Notice of Allowability

09/977,154

EXAMINER'S AMENDMENT AND STATEMENT OF REASONS FOR ALLOWANCE

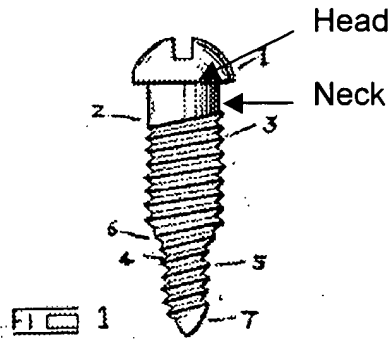
Although Miller discloses that the head 1 of screw can be omitted (col. 1, lines 28-32), this does not eliminate the neck portion (see marked up Figure 1 below). Thus, the shank of the Miller screw is not fully threaded from a proximal end to a distal end. Further, Miller does not disclose that the distal section 4 is longer than the proximal threaded section.
